AMENDMENTS TO THE DRAWINGS

REMARKS

FIG. 8(b)

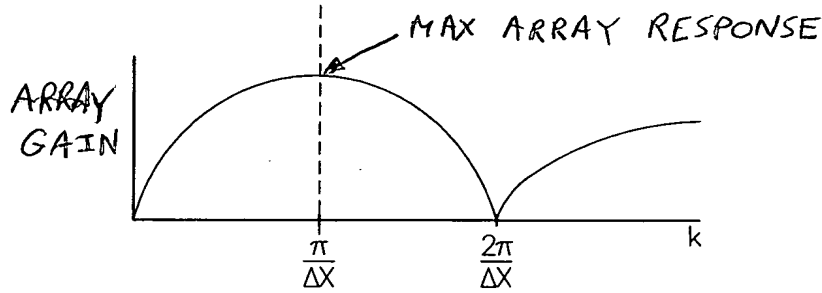
The attached sheet of drawings includes changes to Fig. 8(a). This sheet, which includes Figs. 8(a), 8(b) and 8(c), replaces the original sheet including Figs. 8(a), 8(b) and 8(c). In Fig. 8(b), previously omitted element Array Gain Plot has been added.

1. Examiner objected to portions of the disclosure. Applicants have amended the disclosure and request that these objections be withdrawn.
2. Examiner objected to Fig. 8(b). Applicants have amended Fig. 8(b) to include text to describe the plot as an Array Gain plot. Applicants request that this objection be withdrawn.
3. Claim 12 has been objected to because of informalities. Claim 12 has been amended to depend from claim 11. Applicants request that this objection be withdrawn.
4. The Examiner has rejected claims 1-3, 5-6, 10-13, 15-16 and 20 under 35 U.S.C. 102(b) as being anticipated by Baumoel (6,026,693).
